# FOUNDATION LUTHERAN CHURCH

## GRADING AND EROSION CONTROL CONSTRUCTION DOCUMENTS

SHEET NAME  
GEC COVER

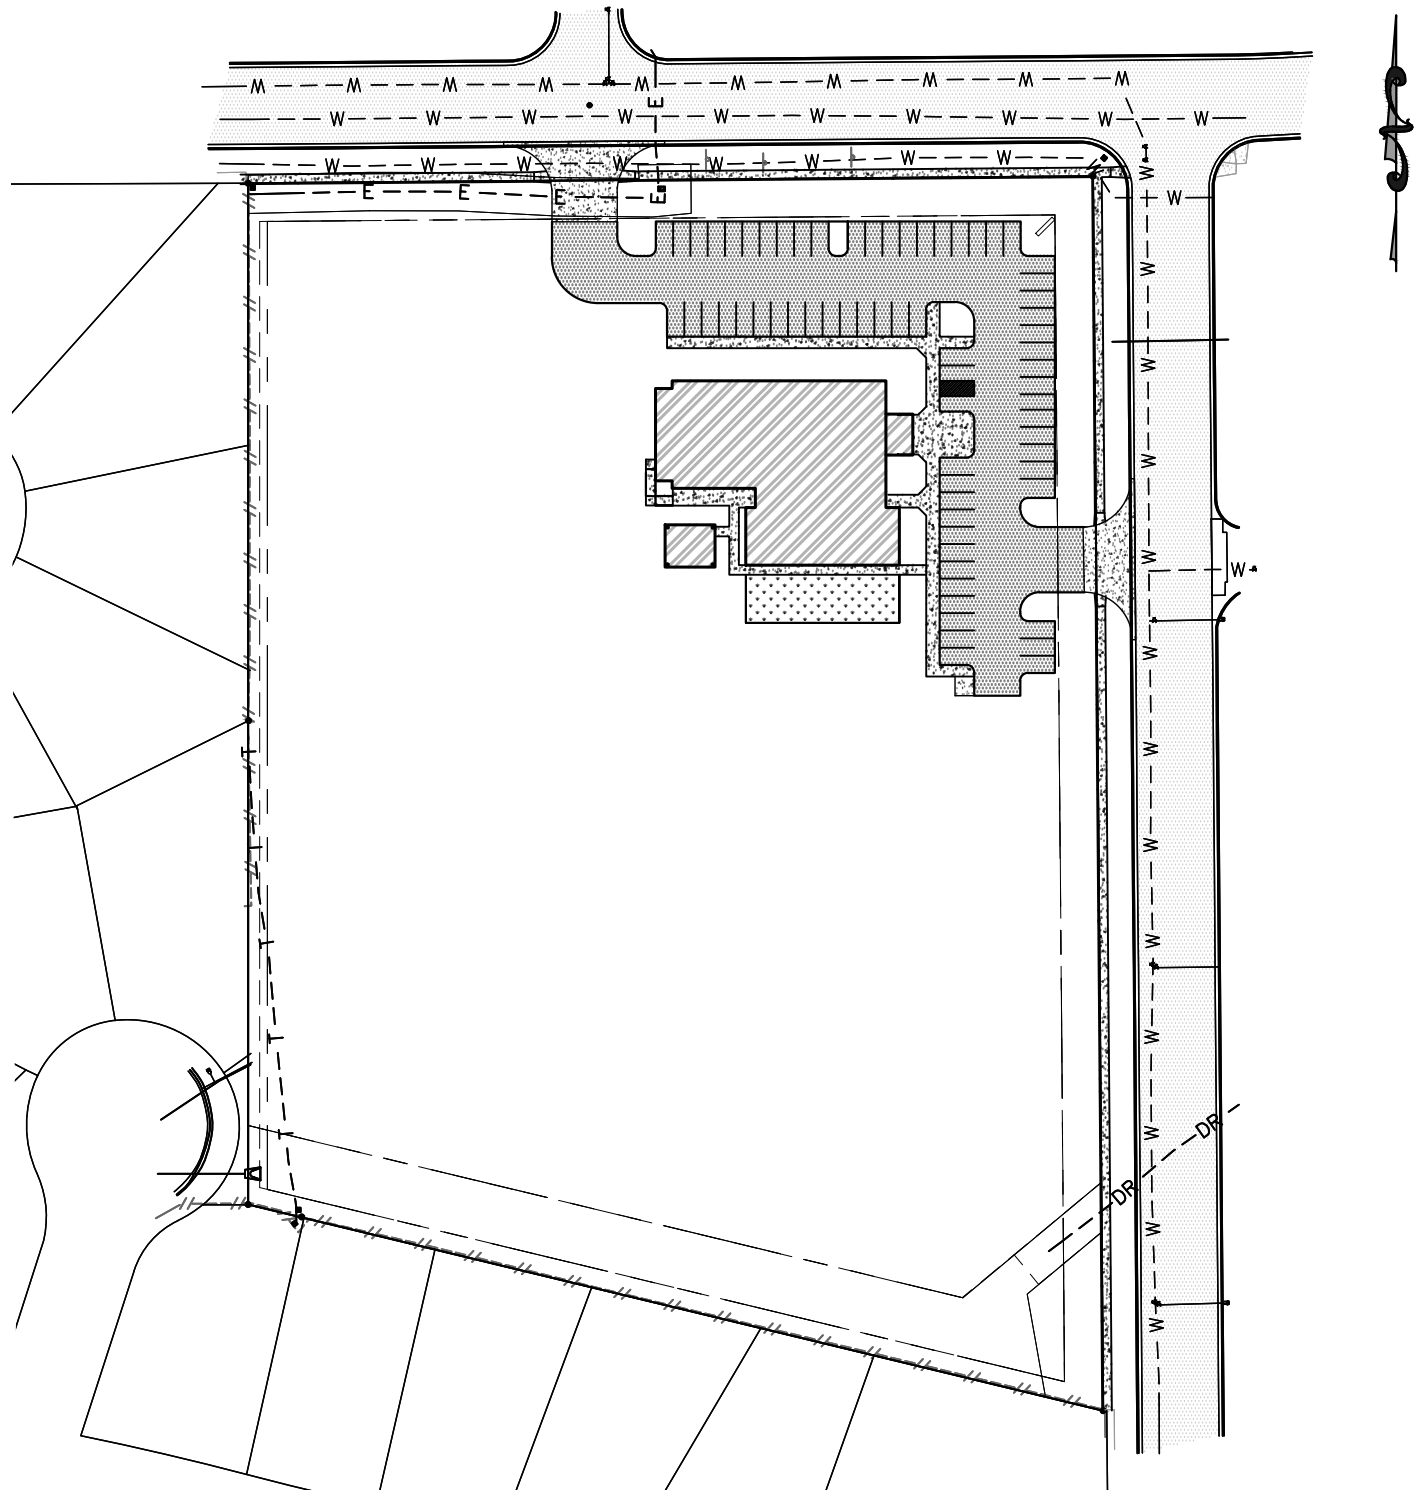
Update site development plan to reflect all changes made in drainage report and construction drawings. Such as the change in pipe sizes, etc.

CUT AND FILL PLAN

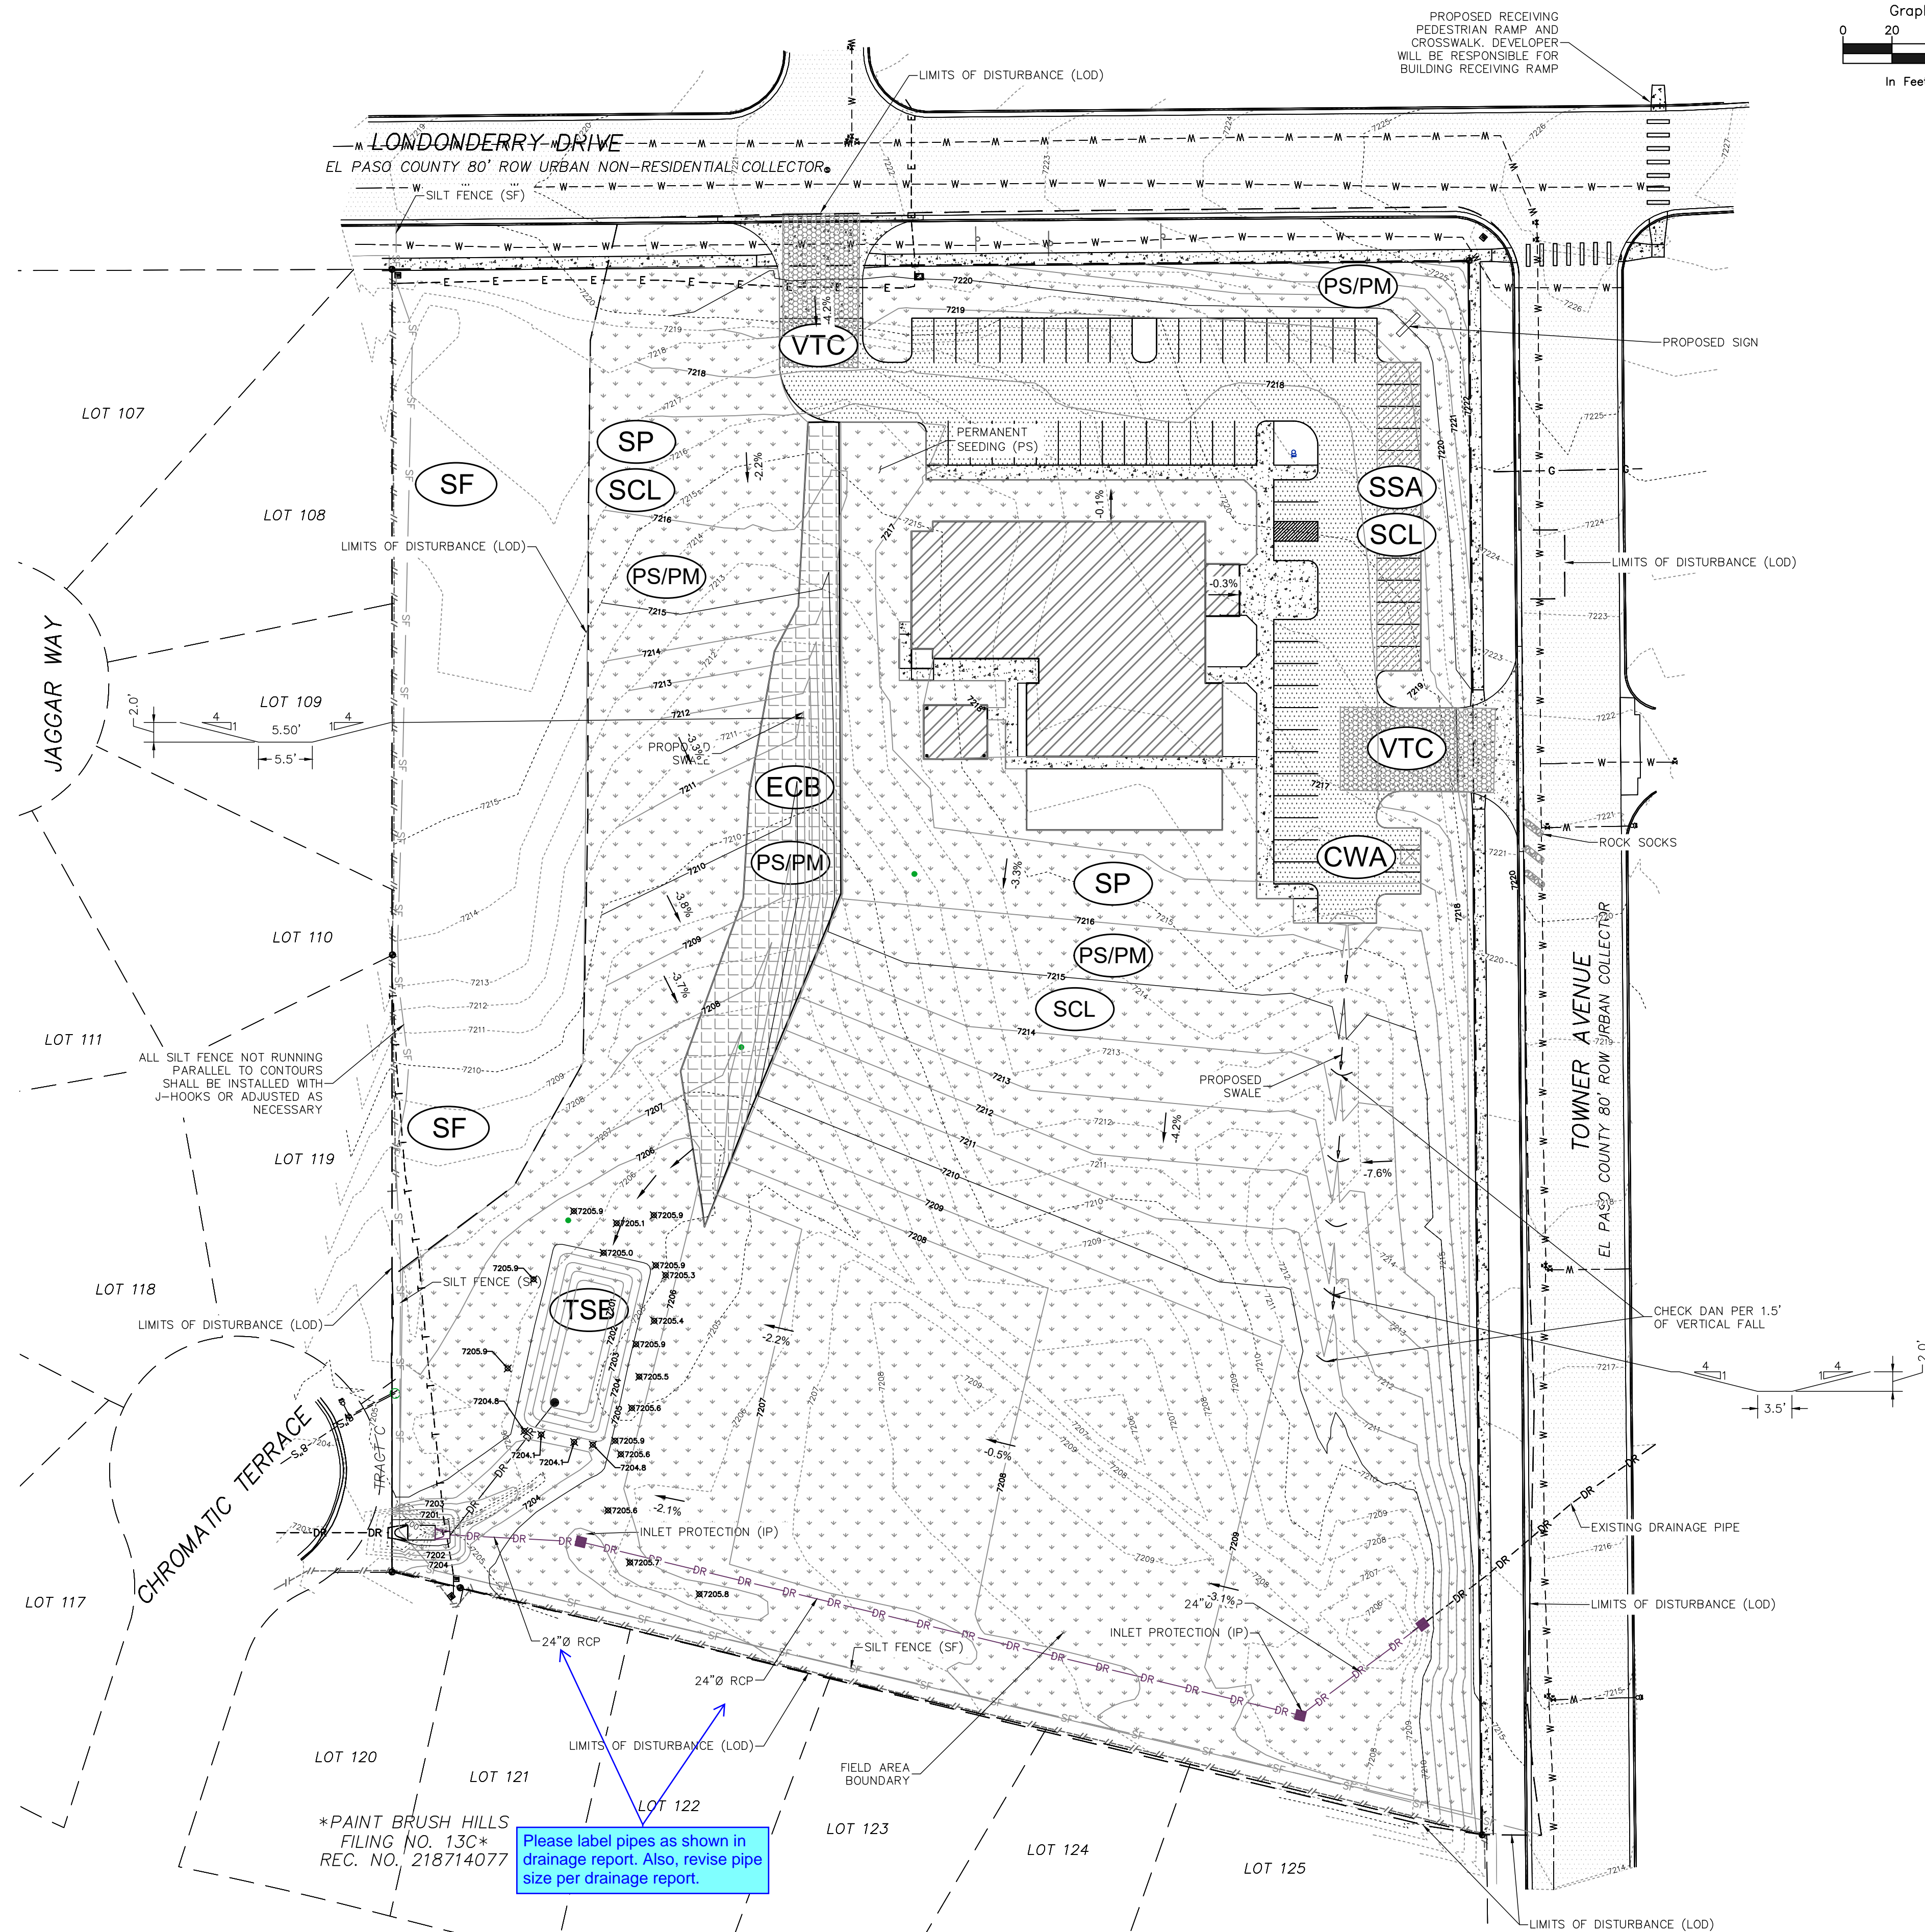
Please label pipes as shown in drainage report. Also, revise pipe size per drainage report.
